500 TERRY AVENUE

RECOMMENDATION MEETING

DPD #3012929 | DECEMBER 12, 2012

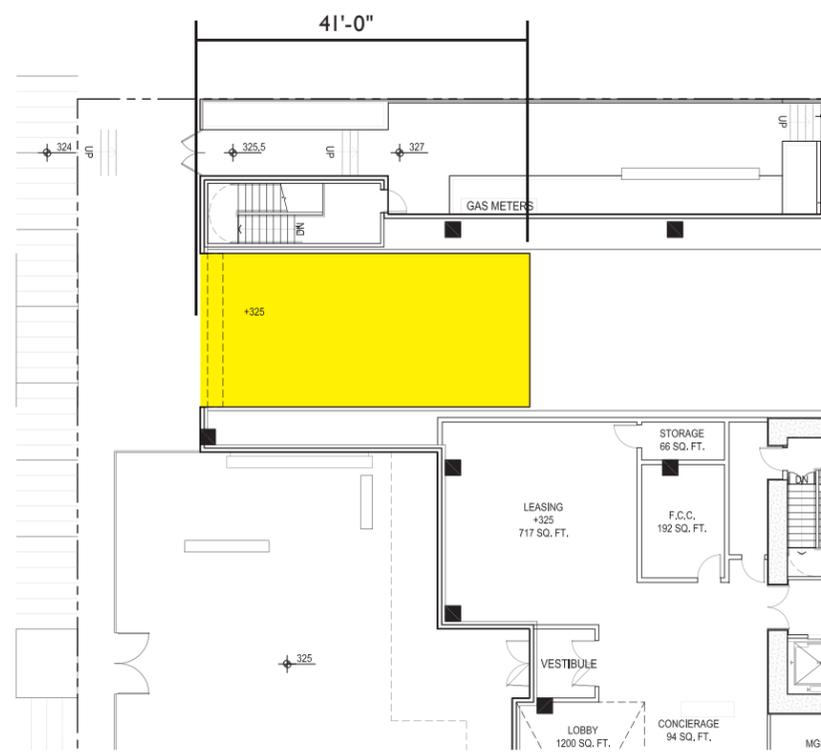
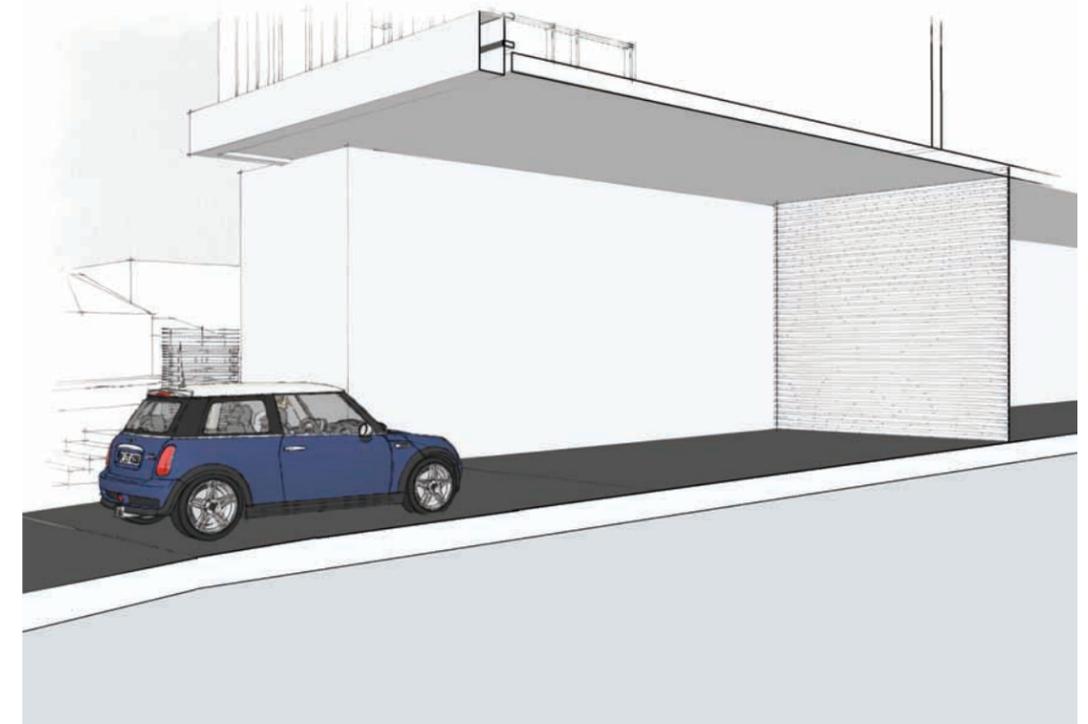
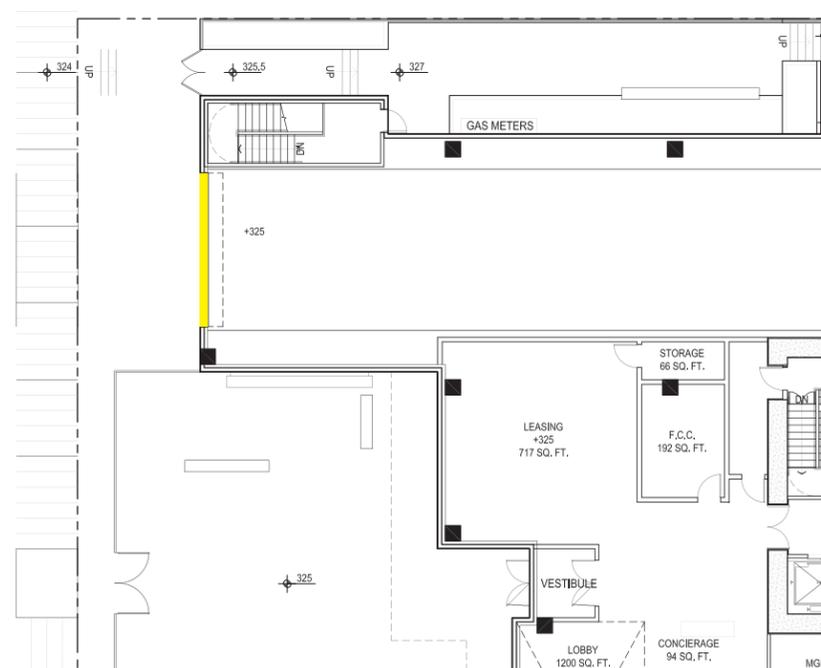
DEPARTURE:	FOUR
DEVELOPMENT STANDARDS	25.45.536.D.3.b
REQUIREMENT	Garage doors facing the street shall be set back at least 15 feet from the street lot line, and shall be no closer to the street lot line than the street-facing facade of the structure.
PROPOSED	Garage doors facing the street shall be set back at least 15 feet from the street lot line, the remaining façade of the structure will be 10 feet 6 inches from the property line.

The podium is cantilevered out above the ground floor on the Terry Avenue side to create a hierarchy between garage/service and residential. The Residential portion floats above the parking below.

The garage entry is closer to the street than the main pedestrian entry (front door) for two fundamental reasons:

- The garage entry nearer to Terry quickly eliminates and visually separates vehicles from the on-site public realm.
- The main pedestrian building entry is as far away from Terry as is reasonably possible to maximize the open space

Lastly, At EDG, the board supported the extension of the podium west towards Terry, better defining the space while creating a sense of embracing of the open space.
